### **ADDENDUM #3**

Bid #CM-17-18-01-NEC-01-XX North Education Center Interim Village Project

### **BID PACKAGE F: LANDSCAPING**

#### **Palomar Community College District**

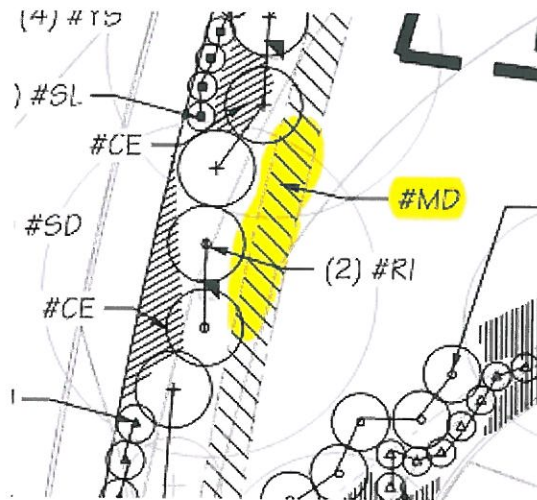
- Remove many CO symbol shrubs and replace some of the CO removed areas with a 1 gallon ground cover.
- Sheet 7.1 detail J added for vegetated swale along east side of Comet Trail North between the northern connection to Horse Ranch Creek Road and the northern end of Parking Lot A.

The swale is typically represented on the new planting plans as follows:
